**METROPOLITAN GOVERNMENT OF NASHVILLE AND DAVIDSON COUNTY**

**STAFF RECOMMENDATION**  
**3815 Central Avenue**  
**January 18, 2012**

**Application:** New Construction—Addition  
**District:** Richland-West End Neighborhood Conservation Zoning Overlay  
**Council District:** 24  
**Map and Parcel Number:** 10312027300  
**Applicant:** John and Linsay Ozier  
**Project Lead:** Melissa Baldock, melissa.baldock@nashville.gov

<p><b>Description of Project:</b> Proposed construction of a rear addition; a portion of the addition will be wider than the existing historic house. A non-contributing shed will be demolished as part of the project.</p> <p><b>Recommendation Summary:</b> Staff recommends approval of the project with the following conditions:</p> <ol style="list-style-type: none"> <li>1. staff review and approve the asphalt shingle color, brick wall, and stone (if the fireplace is constructed);</li> <li>2. the windows have fully simulated divided lights;</li> <li>3. the front parking pad area be eliminated from the project.</li> </ol> <p>With these conditions, staff finds the addition proposed for 3815 Central Avenue meets Sections II.B.1. and II.B.2. of the <i>Richland-West En

PROPOSED SITE PLAN

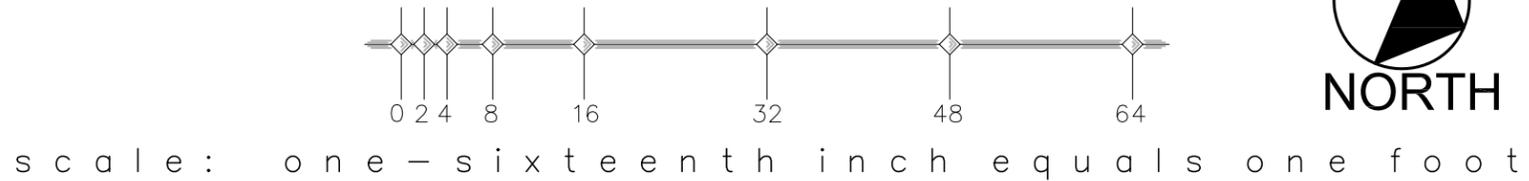
Appurtenances: The site plan indicates that a front yard parking area will be added to the existing curb cut and driveway. Parking pads in front yards do not meet the design guidelines, and staff asks that a condition of approval be that the front parking pad be eliminated from the project. The applicant has agreed to this condition. Staff finds that the addition's proportion and rhythm of openings meets section II.B.1.i. and II.B.2 of the *Richland-West End Neighborhood Conservation District: Handbook and Design Guidelines*.

4. staff review and approve the asphalt shingle color, brick wall, and stone (if the fireplace is constructed);
5. the windows have fully simulated divided lights;
6. the front parking pad area be eliminated from the project.

ELEVATION TWO

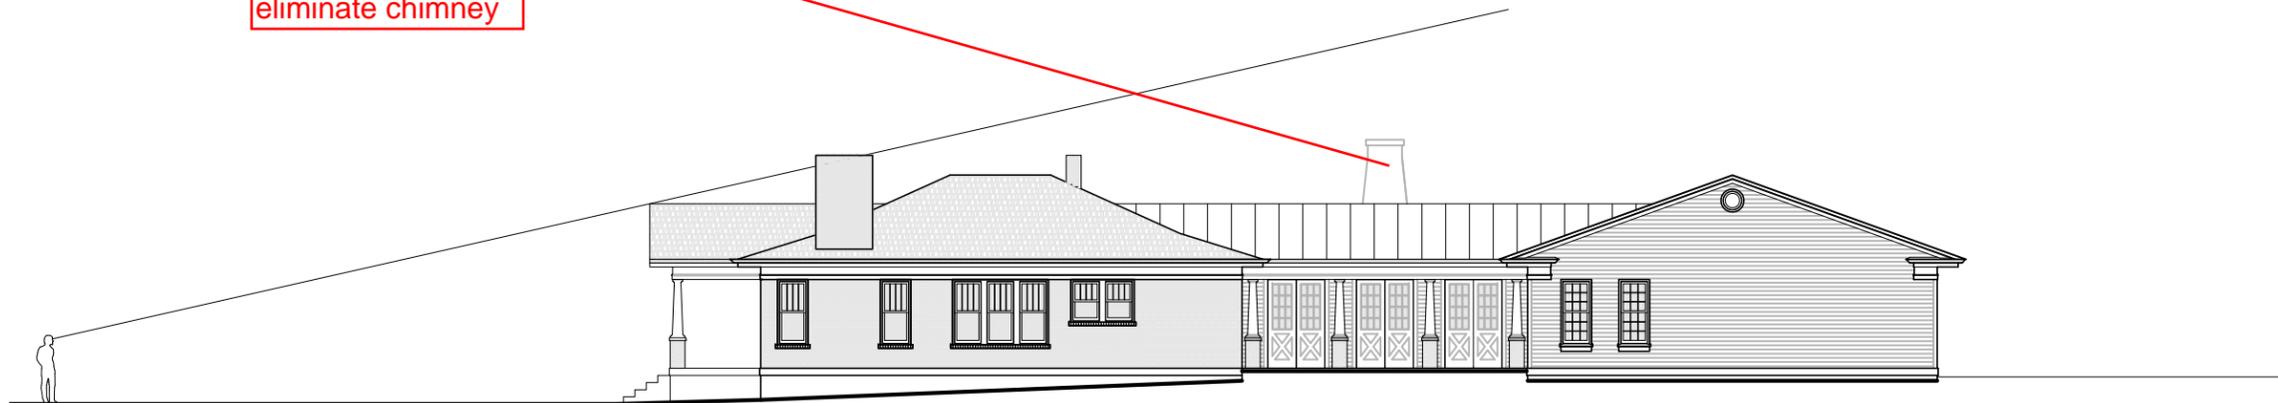
MHZC Note:  
applicant will likely  
eliminate chimney
